Access Compliance Report

Public Rights-of-Way

(Curb Ramps)

Intersection ID: 5600	Main Street: N_TRYON_ST	Cross Street: J_M_KEYNES_DR	Location: E
ADA ID: 8AFBB9586ED7	Ramp Type: Perp	Initial Pass/Fail: Fail	Overall Compliance: No
Severity Score: 21.25			
Codes/Mitigation Info/Possible Solution		Field Measurements/Component Compliance

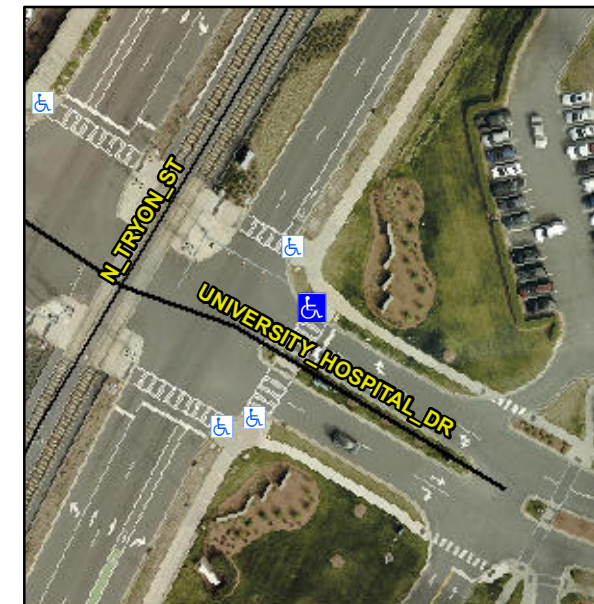
R304.5.1, R304.2.2

Compliance	Description	Data	Compliance	Description	Data
N/A	Ramp Length (in)	94.0	No	Ramp Slope (%)	8.6
No	Ramp Width (in)	47.0	Yes	Ramp XSlope (%)	0.0
N/A	Flare Type LT	N/A	N/A	Flare Type RT	N/A
N/A	Flare Slope LT (%)	N/A	N/A	Flare Slope RT (%)	N/A
N/A	Flare Traversable LT?	N/A	N/A	Flare Traversable RT?	N/A
N/A	Landing Length (in)	N/A	N/A	DWS Provided?	N/A
N/A	Landing Width (in)	N/A	N/A	DWS Contrast?	N/A
N/A	Landing Slope (%)	N/A	N/A	DWS Length (in)	N/A
N/A	Landing X Slope (%)	N/A	N/A	DWS Full Width?	N/A
N/A	Landing Curb? (Y/N)	N/A	N/A	DWS Offset (in)	N/A
N/A	Shared Landing?	N/A			
N/A	Gutter Ponding?	N/A	N/A	Gutter Slope (%)	N/A
N/A	Gutter Lip Ht (in)	N/A	N/A	Gutter X Slope (%)	N/A
N/A	Painted X Walk1?	Yes	N/A	Painted X Walk2?	N/A
	X Walk 1 Direction	To SW		X Walk 2 Direction	N/A
N/A	X Walk 1 Width (in)	146.0	N/A	X Walk 2 Width (in)	N/A
	X Walk 1 Slope (%)	2.8		X Walk 2 Slope (%)	N/A
	X Walk 1 X Slope (%)	4.6		X Walk 2 X Slope (%)	N/A

N/A	Ramp inside XWalk1?	Yes	N/A	Ramp inside XWalk2?	N/A
	Road Slope (%)	N/A	N/A	Clear Space?	N/A
	Road X Slope (%)	N/A	N/A	Clear Space to XWalk (in)	N/A
N/A	Any Obstructions?	N/A	N/A	Storm Grate/Utility Hazard?	N/A
	Obstruction Type			Storm Grate/Utility Type	
		N/A			N/A
			Yes	Surface Condition? (G/P)	Good

Remove & Replace Entire Ramp.
